Access Compliance Report

Public Rights-of-Way

Intersection ID: 11553	Main Street: MCKINLEY_DR	Cross Street: THORNTON_RD	Location: NW
ADA ID: B7EBA0CAE1C9	Ramp Type: BlendTrans1	Initial Pass/Fail: Pass	Overall Compliance: No
Severity Score: 0			
Codes/Mitigation Info/Possible Solution		Field Measurements/Component Compliance

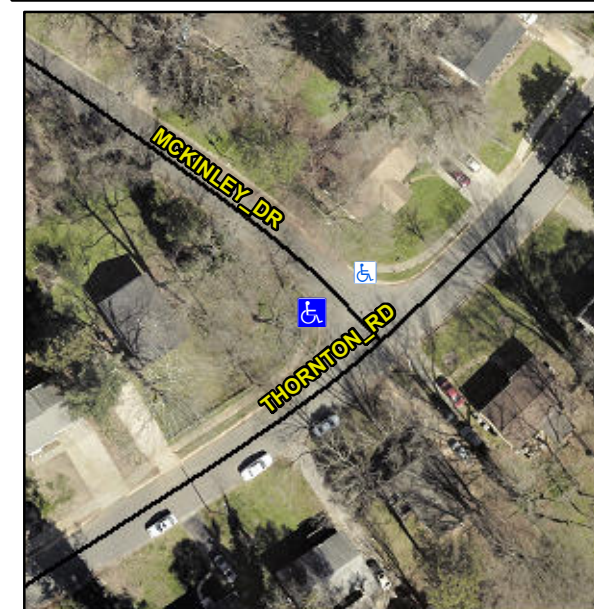
Not Found, R304.2.2-Perp, R304.3.2-Para

Compliance	Description	Data	Compliance	Description	Data
N/A	Ramp Length (in)	48.0	Yes	BlendTrans Slope (%)	4.1
Yes	Ramp Width (in)	48.0	Yes	BlendTrans XSlope (%)	0.1
N/A	Flare Type LT	Sloped	N/A	Flare Type RT	Sloped
N/A	Flare Slope LT (%)	2.7	N/A	Flare Slope RT (%)	3.1
N/A	Flare Traversable LT?	No	N/A	Flare Traversable RT?	No
Yes	Landing Length (in)	59.5	Yes	DWS Provided?	Yes
Yes	Landing Width (in)	48.0	Yes	DWS Contrast?	Yes
No	Landing Slope (%)	2.3	Yes	DWS Length (in)	24.0
Yes	Landing X Slope (%)	0.4	Yes	DWS Full Width?	Yes
N/A	Landing Curb? (Y/N)	No	Yes	DWS Offset (in)	0.0
N/A	Shared Landing?	No			
Yes	Gutter Ponding?	No	Yes	Gutter Slope (%)	1.8
Yes	Gutter Lip Ht (in)	0.0	Yes	Gutter X Slope (%)	0.3
N/A	Painted X Walk1?	No	N/A	Painted X Walk2?	N/A
	X Walk 1 Direction	To NE		X Walk 2 Direction	N/A
	X Walk 1 Width (in)	N/A		X Walk 2 Width (in)	N/A
	X Walk 1 Slope (%)	4.0		X Walk 2 Slope (%)	N/A
	X Walk 1 X Slope (%)	0.3		X Walk 2 X Slope (%)	N/A

N/A	Ramp inside XWalk1?	N/A	N/A	Ramp inside XWalk2?	N/A
	Road Slope (%)	0.3		Clear Space?	Yes
	Road X Slope (%)	4.0	N/A	Clear Space to XWalk (in)	N/A
Yes	Any Obstructions?	No	Yes	Storm Grate/Utility Hazard?	No
	Obstruction Type			Storm Grate/Utility Type	
		N/A			N/A
			Yes	Surface Condition? (G/P)	Good
			No	Curb Slope (%)	16.7

Remove & Replace Curb Ramp With Two New Directional Ramps or Equivalent.
